YANKEE ATOMIC ELECTRIC COMPANY

Subject: Response to the NRC Questions on RELAP5YA

RESPONSE TO 80 QUESTIONS
ON RELAP5YA

July 1, 1985

Figure V.14-4 RELAP5YA Comparison to LOFT L3-6 Data
Pump Differential Pressure

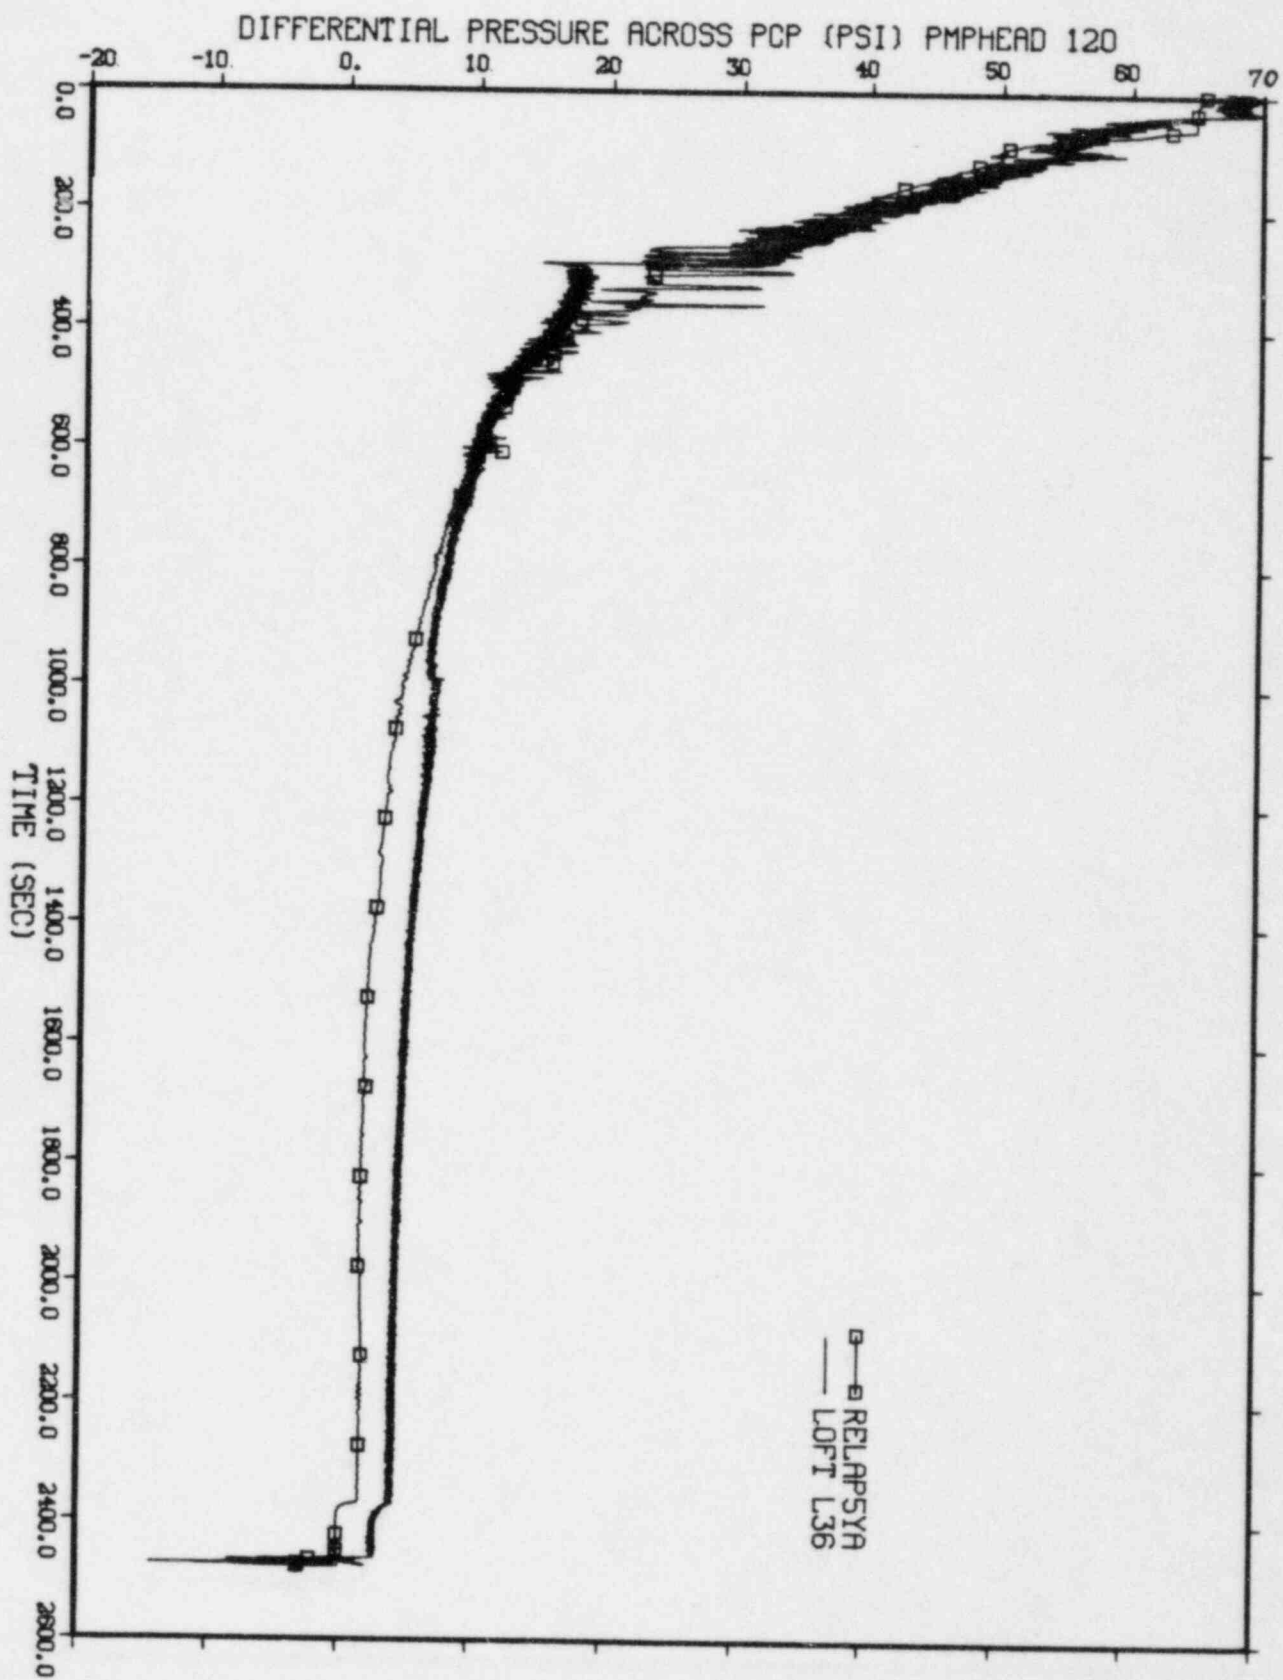
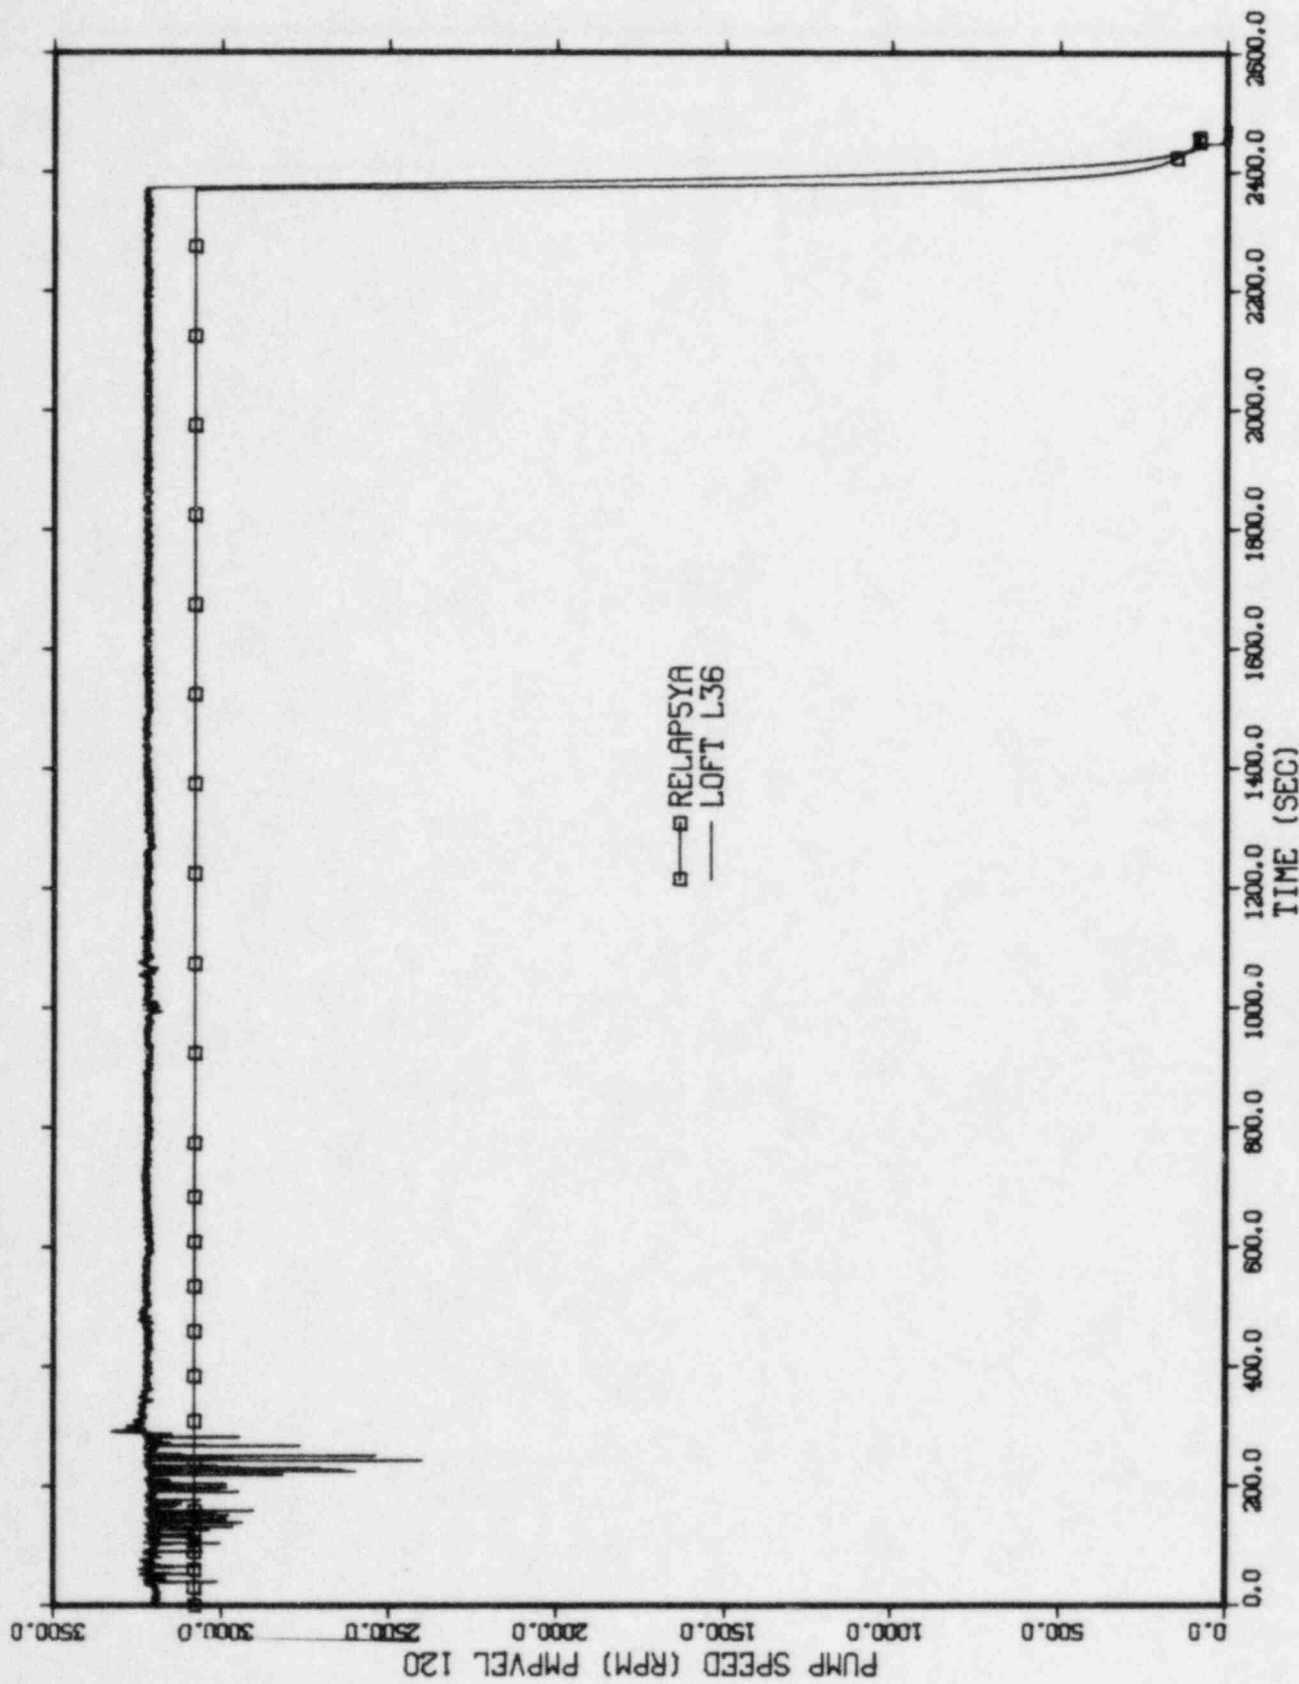
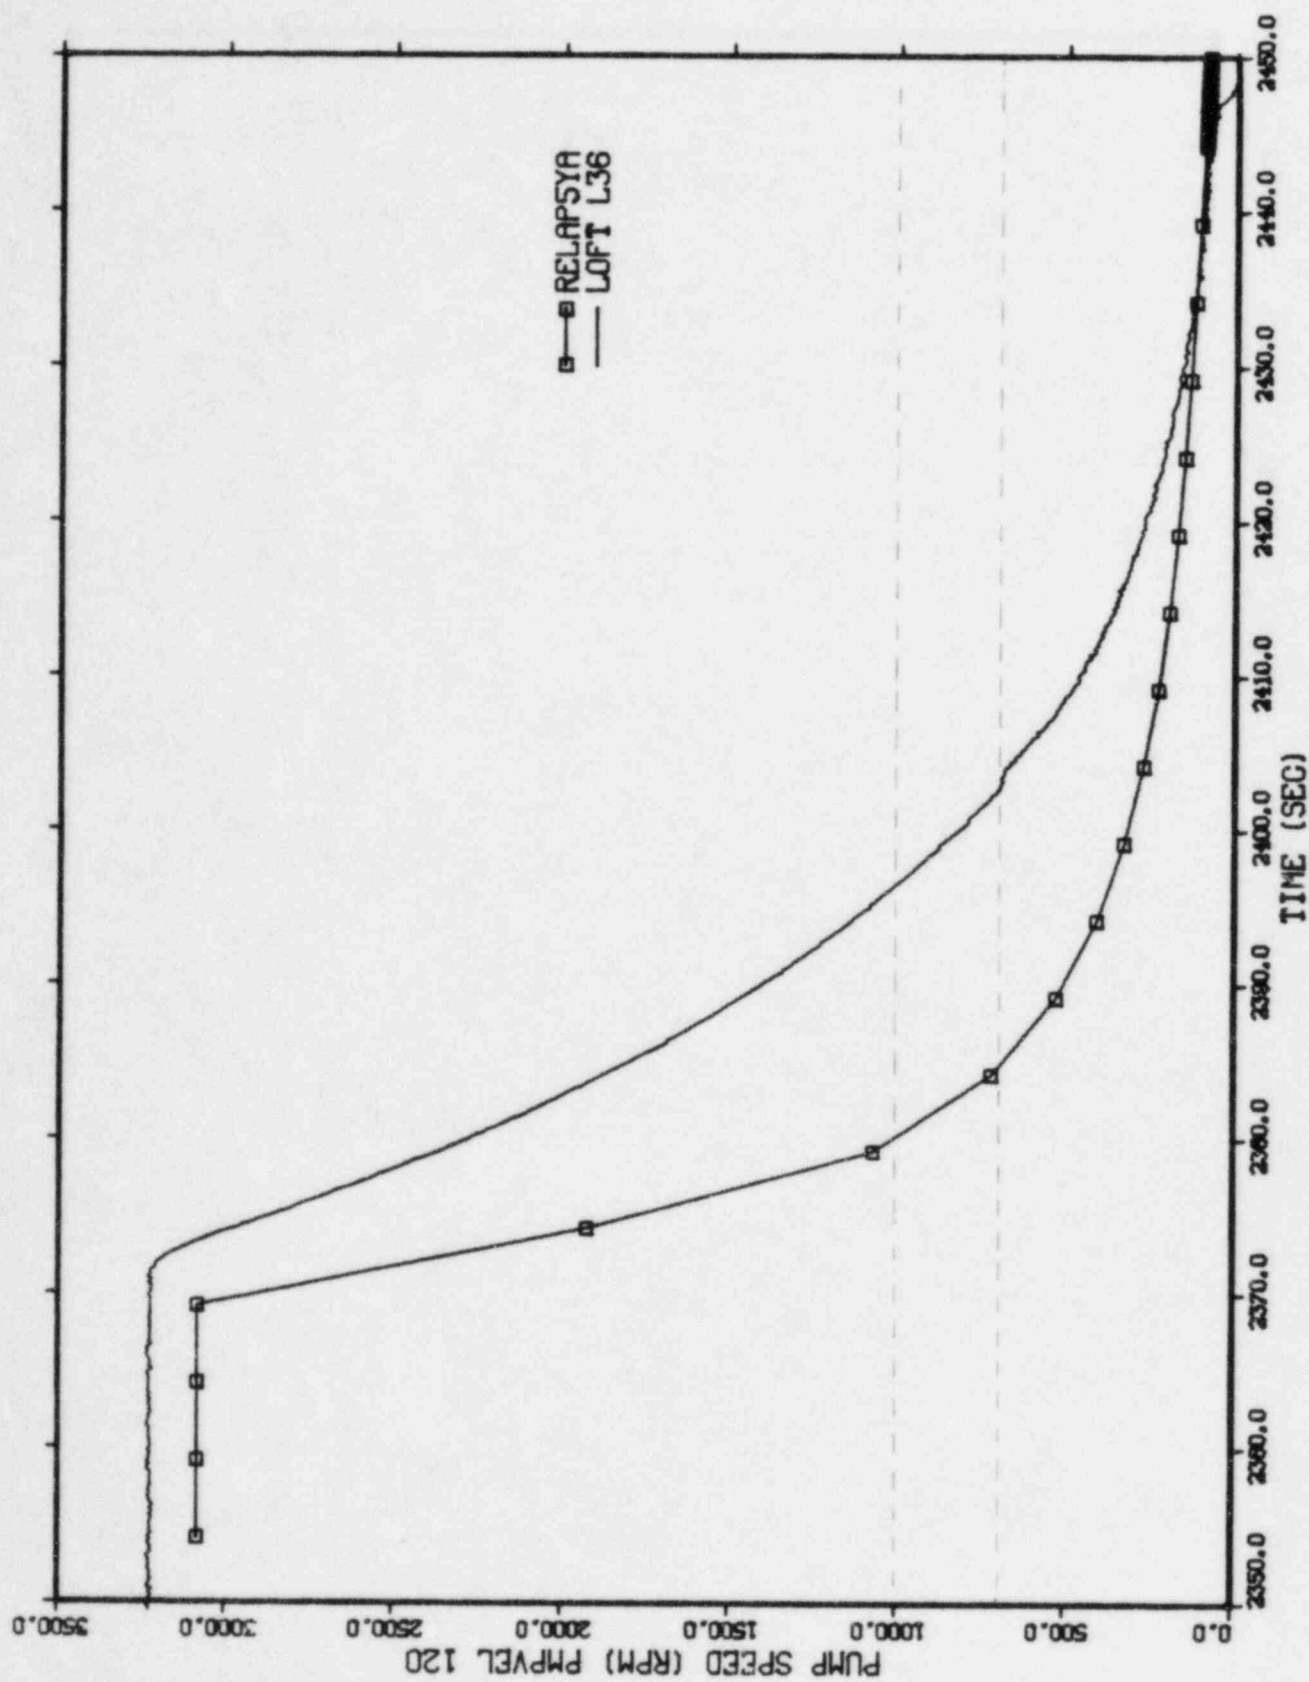
Clarify how prototypical the data used is for full-scale pumps.

Figure V.14-4 compares the calculated pump head to the differential pressure across the two pumps (measurement PdE-PC-001). Both curves show essentially the same head degradation as the fluid changes from initially subcooled liquid to predominantly steam at about 1000 seconds and beyond. This comparison provides confidence in the homologous method for modeling pump two-phase performance.

Figure V.14-5 compares the calculated and measured pump speeds. Both curves show essentially a constant speed during the period when electrical power was supplied to the pumps. This was followed by a rapid coastdown when the pumps were tripped at about 2370 seconds. The spikes in the test data from 0 to 300 seconds are attributed to "unexplained noise" by the EG&G test analysts. A slightly lower initial speed (3082 rpm versus the test value of 3200 rpm) was used to match the flow rates and pressure drops around the primary system.

Figure V.14-6 compares the calculated and measured pump speeds during the coastdown period from 2370 seconds to 2450 seconds. The two curves show similar coastdown trends, but with two notable differences. First, the two curves are offset by about 4.4 seconds due to the lower initial speed and the plotting edit frequency for the calculation versus the measured speed history. Second, the slope of the calculated speed history is more negative than the test data for speeds above 1000 rpm, about the same for speeds between 700 and 1000 rpm, and less negative for speeds below 700 rpm. These differences are primarily due to the fixed value for the pump moment of inertia used in the calculation versus the variable moment of inertia in the LOFT pumps. Table V.14-1 compares the approximate LOFT

Figure VII.17-1 Experimental and Predicted Void Fraction Profiles;
Test 3.09.101.

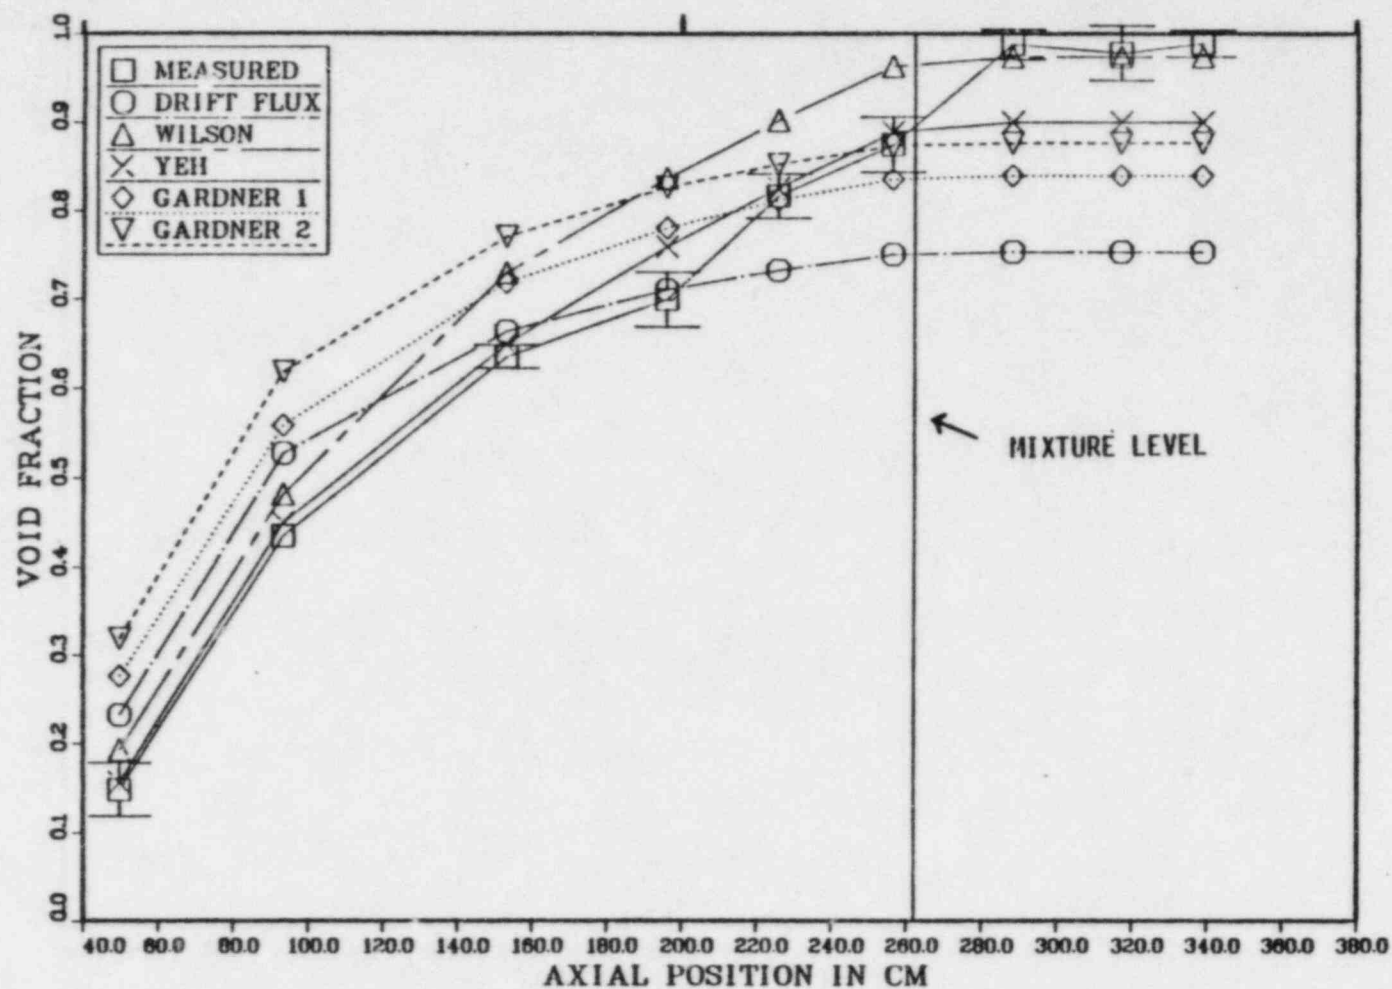
For the quasi-steady-state boil-off test, Figure 5.1-15 of Reference 12 shows the RELAP5YA void fraction is greater than the data above the 4-foot elevation. Page 169 of Reference 12 states: "This figure indicates that the interphase drag values calculated by RELAP5YA may have been somewhat high beyond the 4-foot elevation for this assessment case." Clarify why this is true because it would seem that high drag values would cause more liquid to be carried upward and therefore give lower rather than higher void fractions.

Figure VII.17-1 from Reference VII.17-1 indicates that the inferred mixture level for this test is at about 8.6-foot elevation. The RELAP5YA calculated mixture level at a void fraction of 0.96 is 4.6 feet as shown in Figure 5.1-15 of Reference VII.17-2. Figure 5.1-16 shows that RELAP5YA predicted a dryout CHF that corresponds to the predicted mixture level at 4.6 feet. The test report does not specifically give the CHF location. However, we assume the experimental CHF location occurred at the reported mixture level.
